RE: **Lot 3 Block 3 Unit 22 SAD 228**
6328 Camino Alto NW
Volcano Cliffs Subdivision
Grading and Drainage Plan
Engineers Stamp Date 1/9/19 (D10D003R3)

DRAINAGE AND TRANSPORTATION INFORMATION SHEET (REV 6/2018)

RE: Lot 3, Block 3, Unit 22, Volcano Cliffs Subd., SAD 228 (D10D003R3)
6328 Camino Alto NW

ENGINEER'S SEAL	Title 6328 CAMINO ALTO NW	DRAWN BY
	GRADING AND DRAINAGE PLAN	DATE
		Day
		SHEET #
		1 of 1
		JOB #

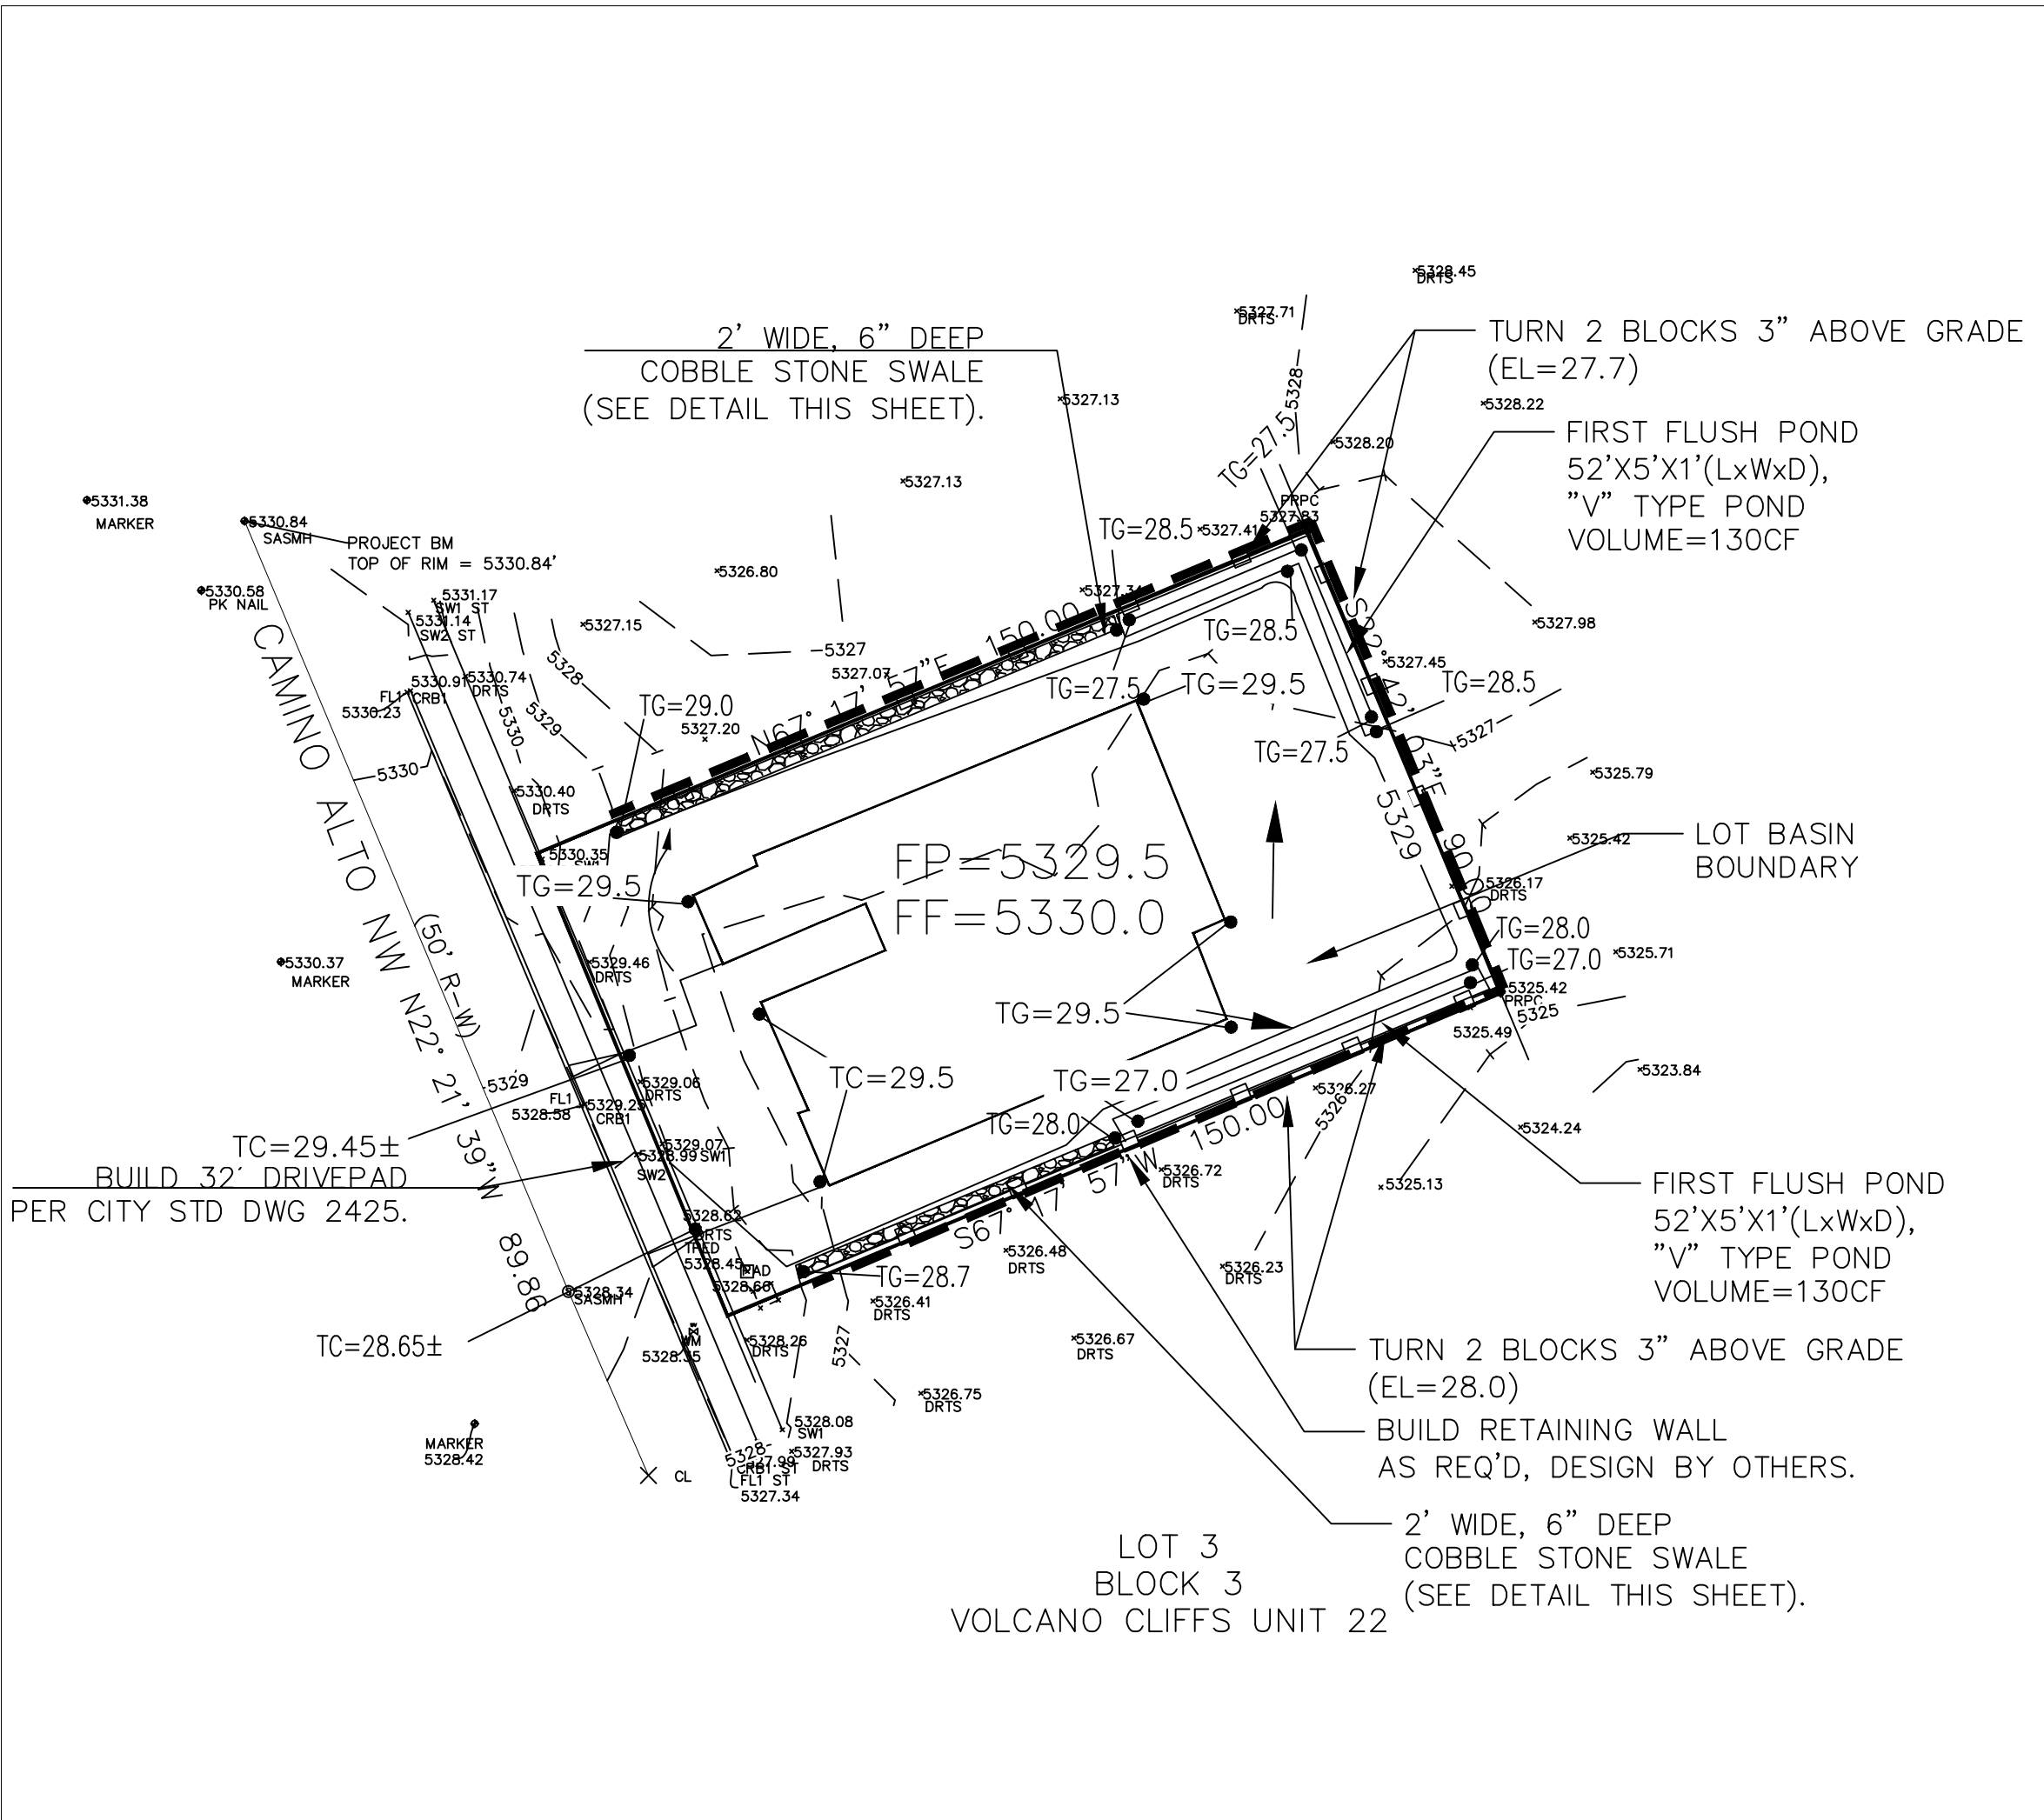
Based upon the information provided in your submittal received 1/10/19, this plan is approved for Grading Permit. Please inform the builder/owner to attach a copy of this approved plan and letter into the construction sets in the permitting process prior to sign-off by Hydrology.

Reiterate to the Owner/Contractor that a separate permit for a garden/retaining wall must be obtained, with the approved G&D plan.

Prior to building permit approval a pad certification will be required.

Prior to Certificate of Occupancy release, Engineer Certification per the DPM checklist of this plan will be required.
